# PLAN OF PROPOSED IMPROVEMENT

## ACACIA RIDGE PHASE 10

CITY PROJECT NO. 14833  
CONTRACT NO. 9340

Revision 2: 05/28/2024  
Sheet U-2: Changed pipe size P-1  
Sheet U-STM: Revised pipes P-1 and P-2,  
revised structures S-1 and S-2

LANDSCAPING PLAN - LONE OAK LN  
 ACACIA RIDGE PHASE 10  
 M:\DESIGN\Projects\14833\CAD\Sites\14833EN-TreeExcavationSites.dwg

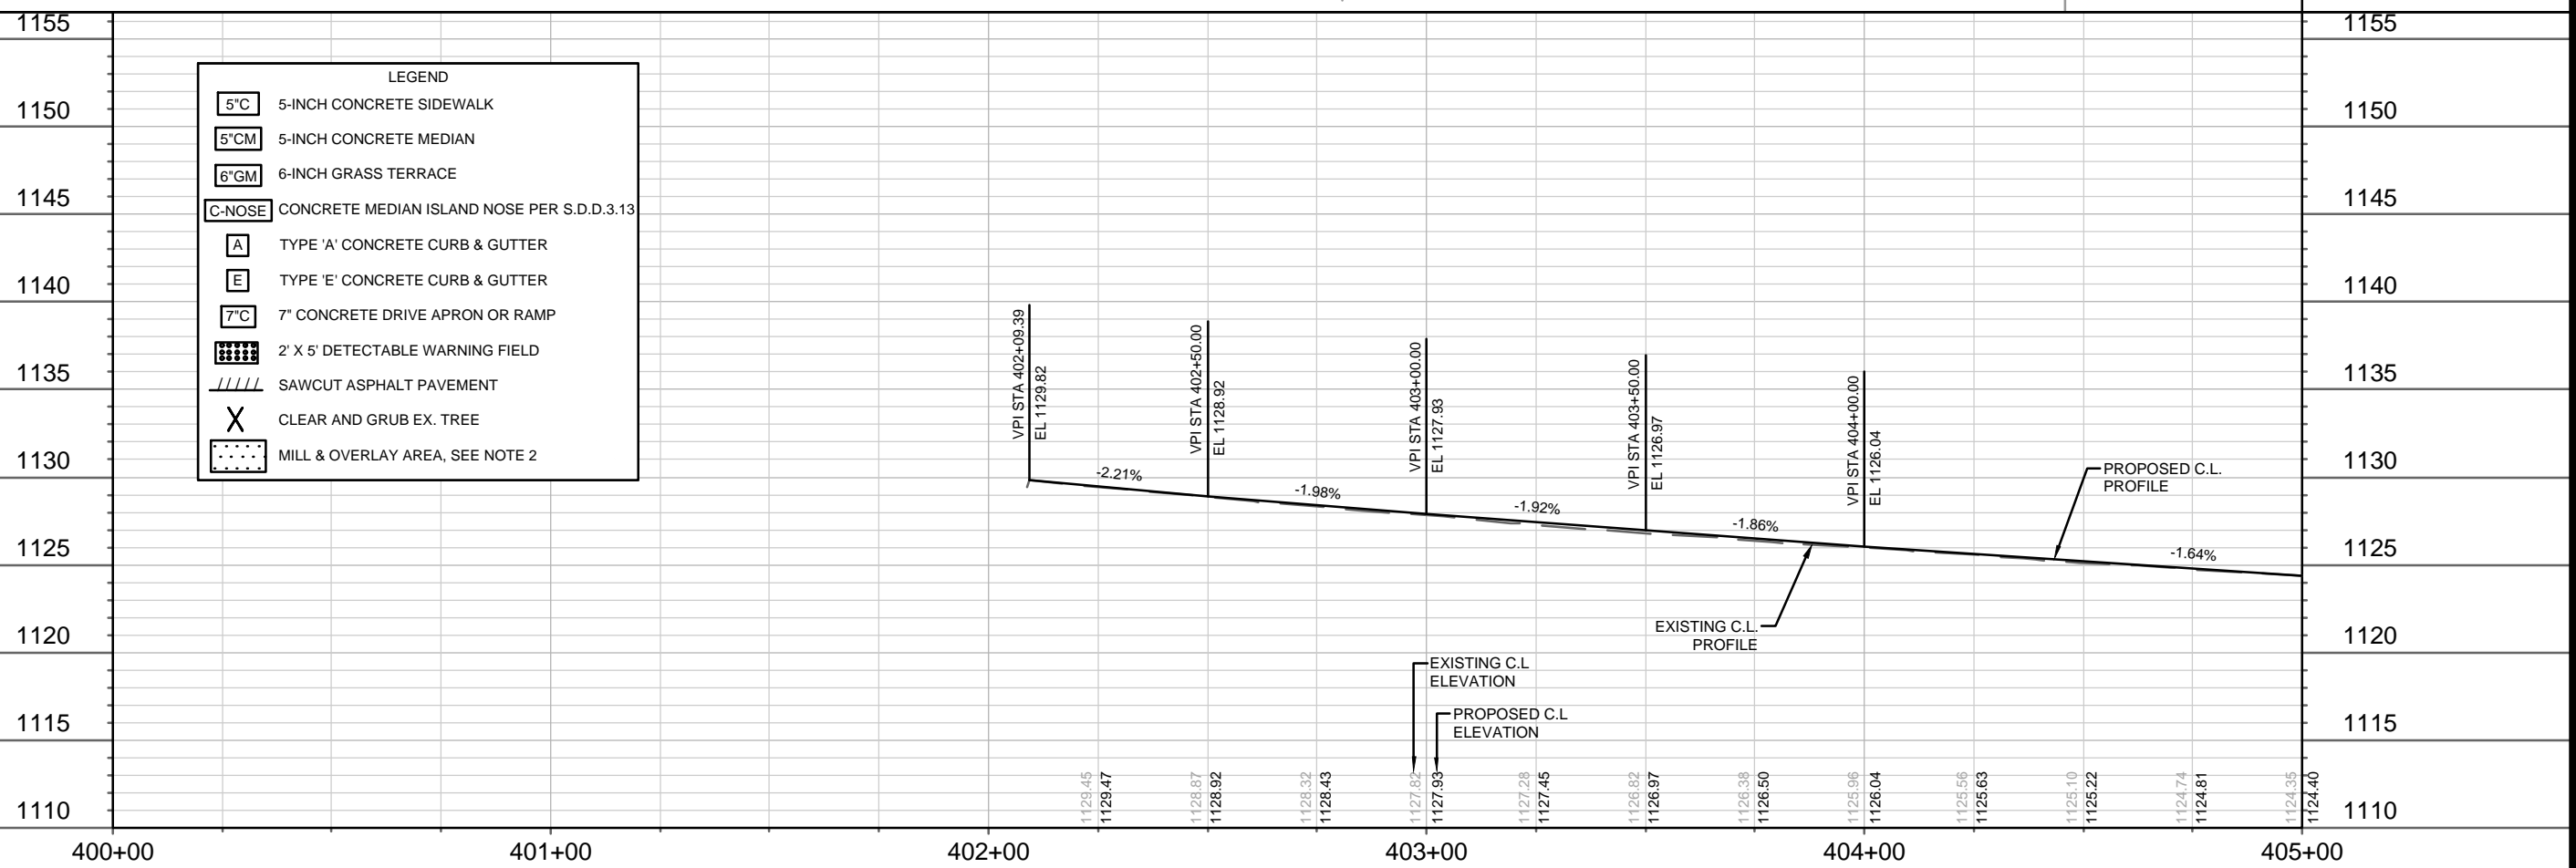
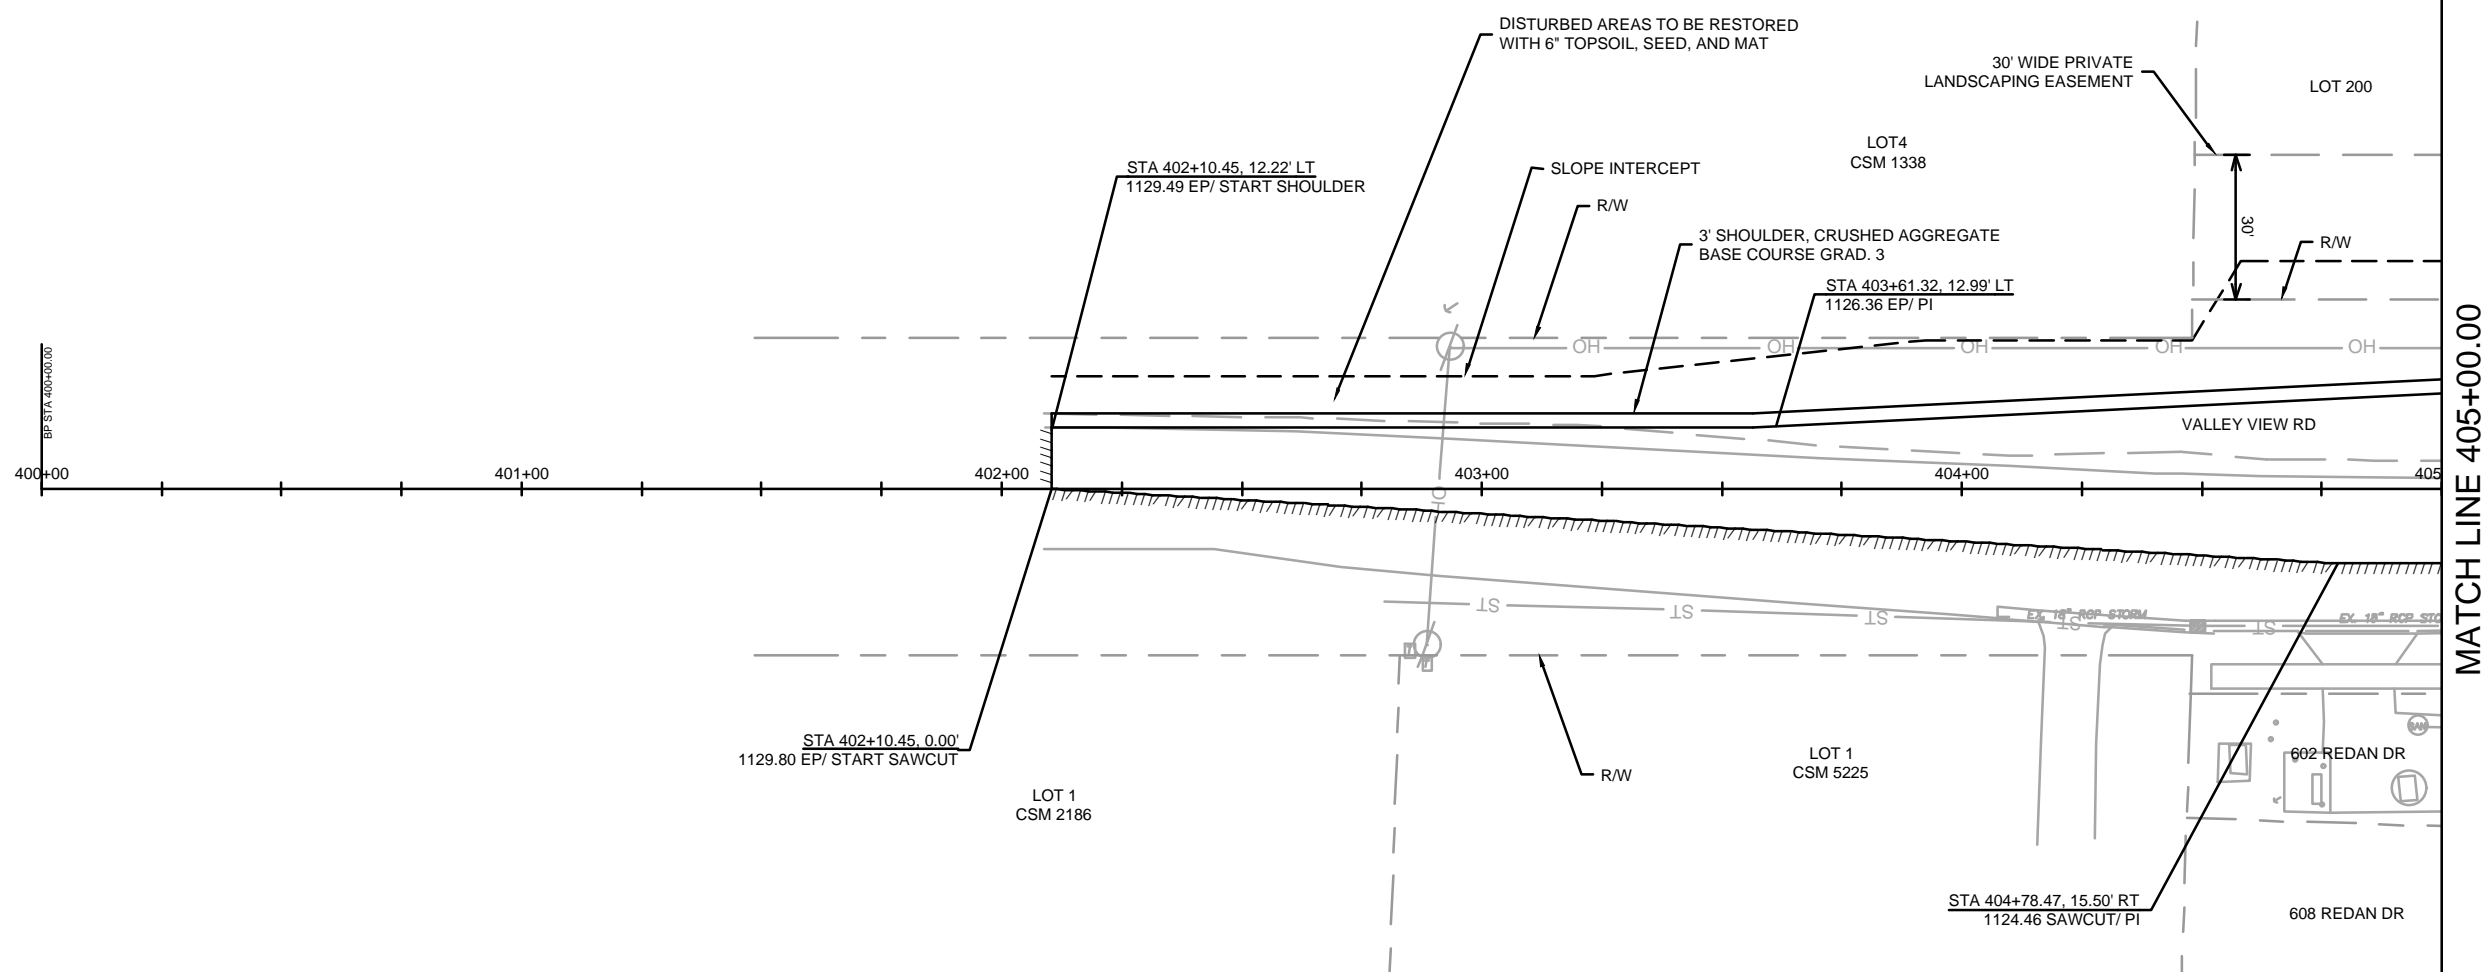
1. PLAN REVISED TO INCLUDE STATION AND OFFSET INFORMATION FOR TERRACE EXCAVATION SITES
